**Re: Union Gas Limited (“Union”)
2017 Storage Enhancement Project
Board File # EB-2016-0322**

REQUEST TO VARY

Project Name: 2017 Storage Enhancement Project

Request to Vary: 1

A map showing the pipelines and access roads that will be removed or abandoned can be found at Schedule 1.

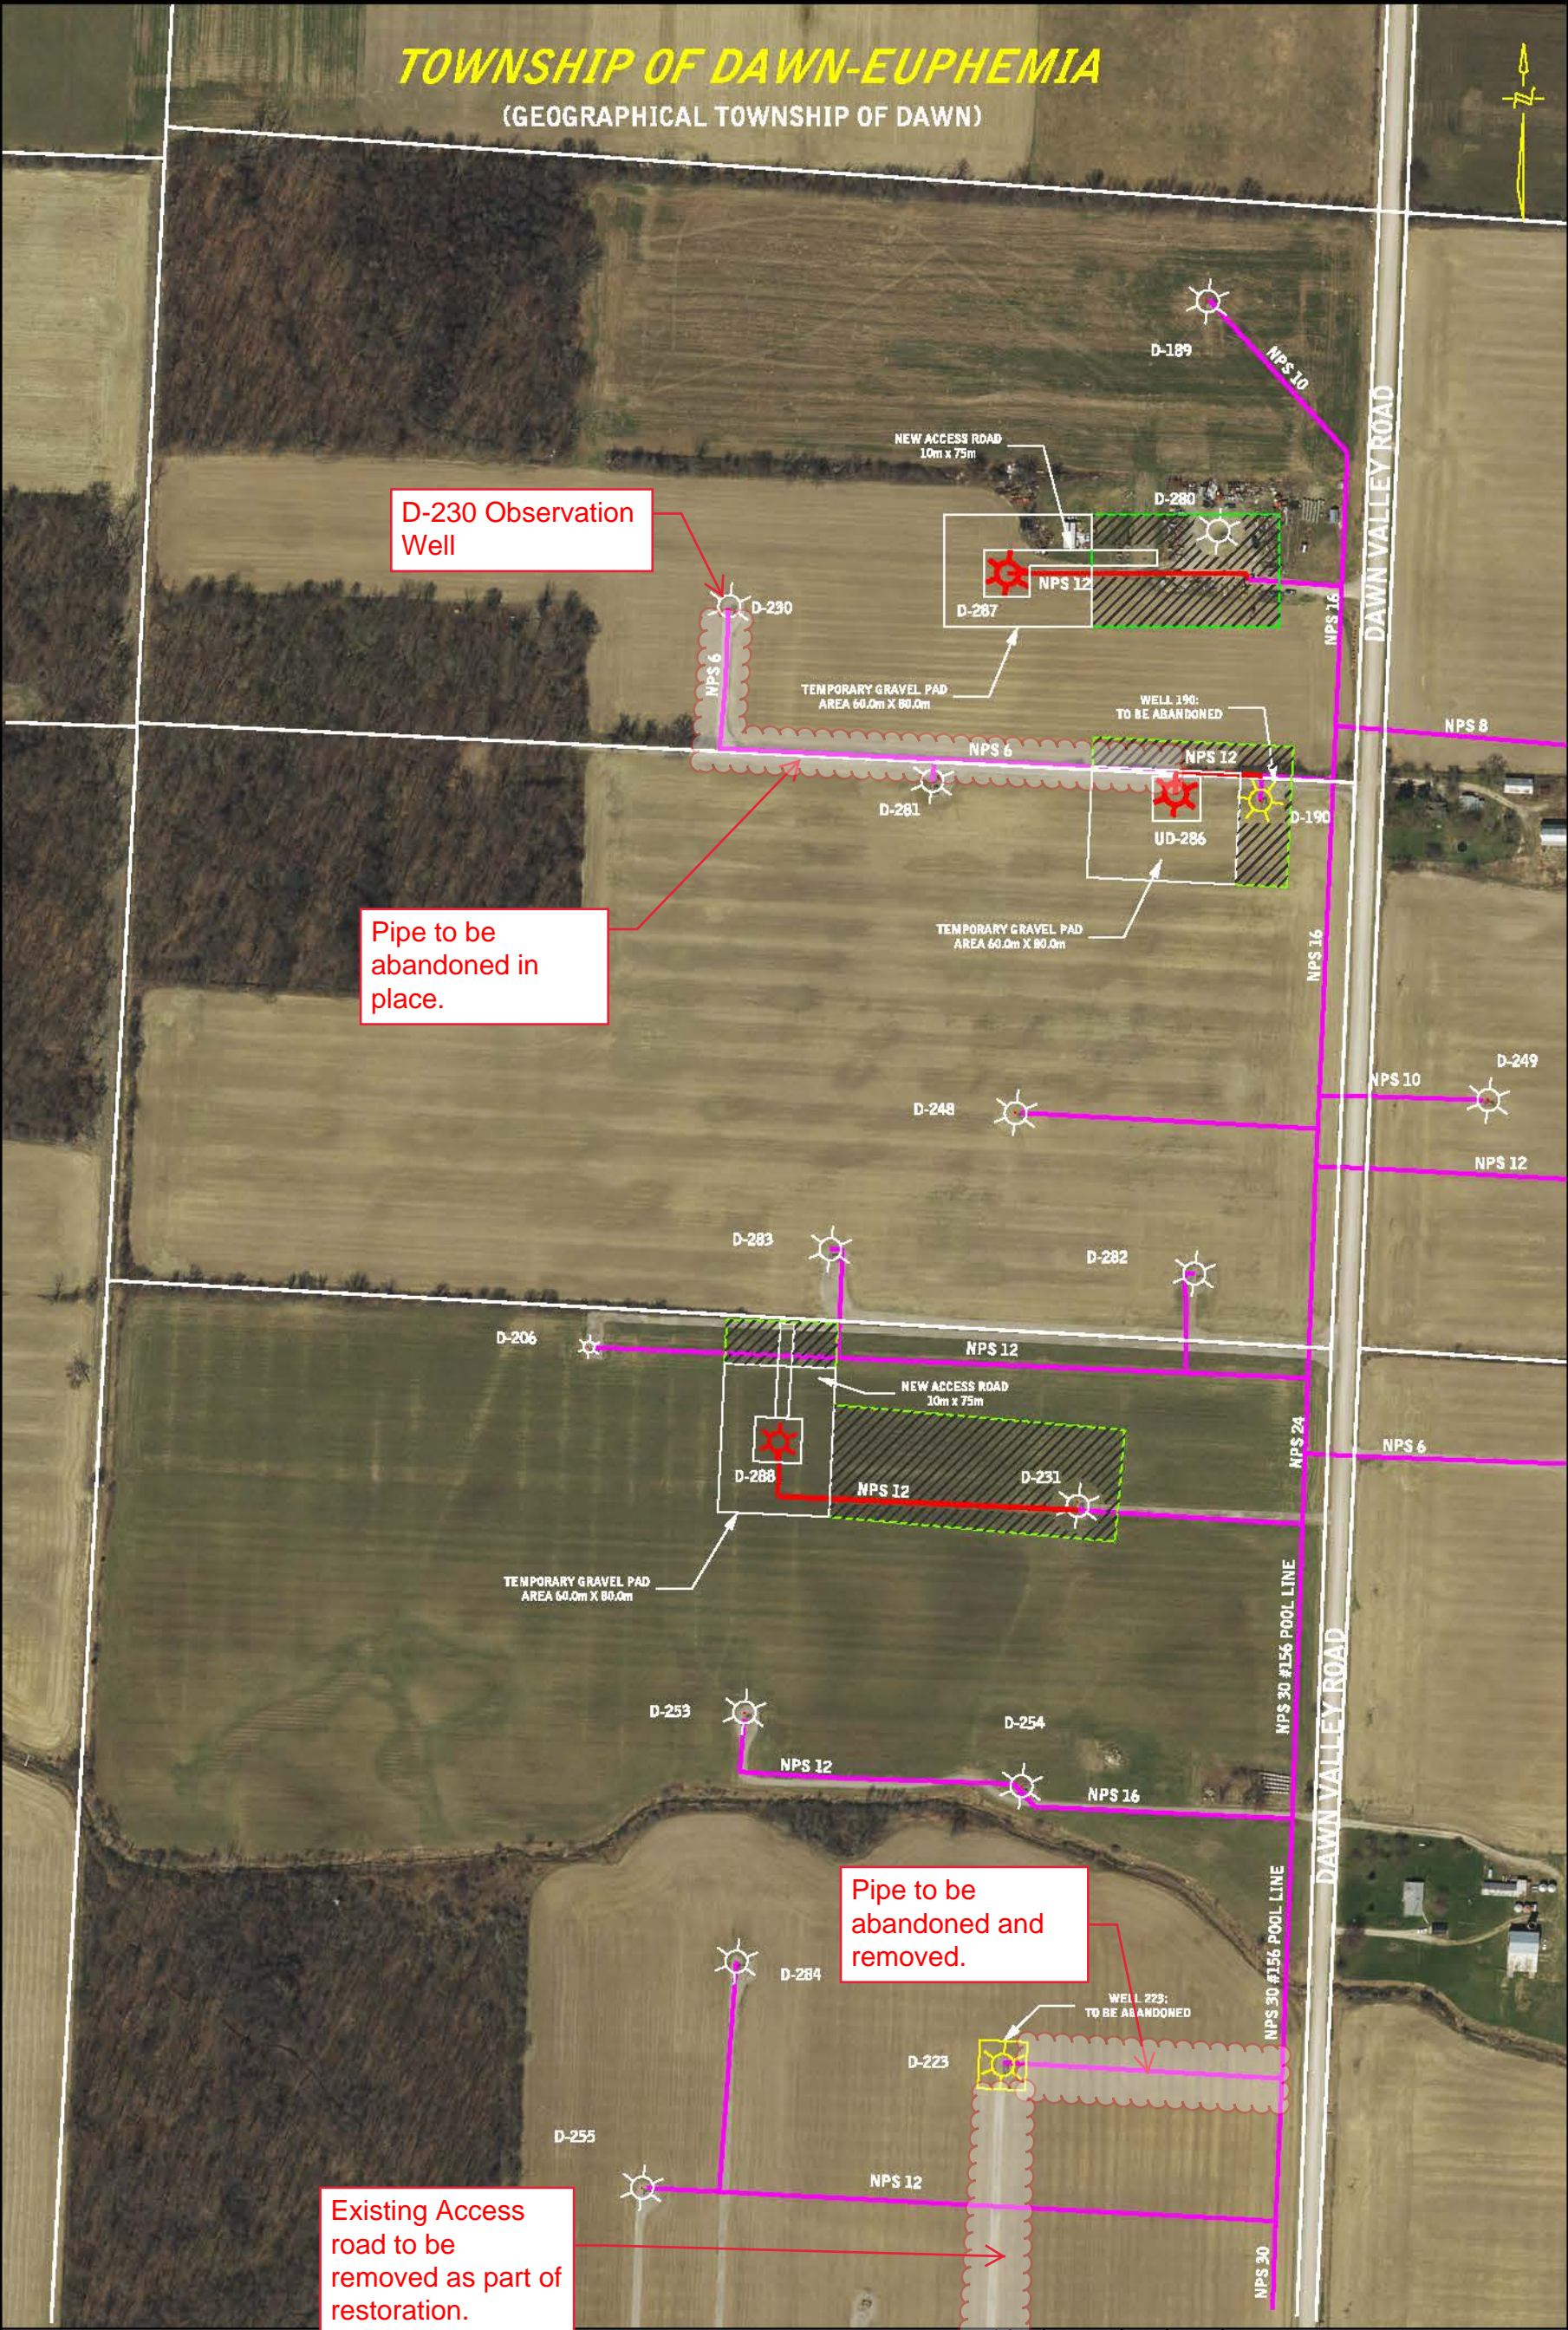
As identified in Unions pre filed evidence Union is proposing to abandon well D-223. After the well has been abandoned Union will remove the gathering pipeline that serves the well, and remove the road access to the well. Removing the pipeline and access road will avoid any future conflicts with agricultural operations in the field. Union's original plan had been to leave the pipeline and road access in place.

As identified in Unions pre-filed evidence Union is proposing to convert well D-230 to an observation well. Once this well has been converted to an observation well it is no longer necessary to have the well connected to the gathering system in the Pool. The NPS 6 gathering pipeline between Wells D-286 and D-230 will be abandoned. Due to its proximity of the gathering line to the existing road network that is still required, it is Unions plan is to abandon this pipeline in place following the TSSA guidelines. Union's original plan had been to leave the observation well connected to the gathering system

Union would also like to correct an omission on Schedule 11 of the pre filed evidence. This schedule shows well D-219 and an NPS 4 pipeline connecting this well to the gathering system. This well was abandoned and the gathering pipeline removed in 2007.
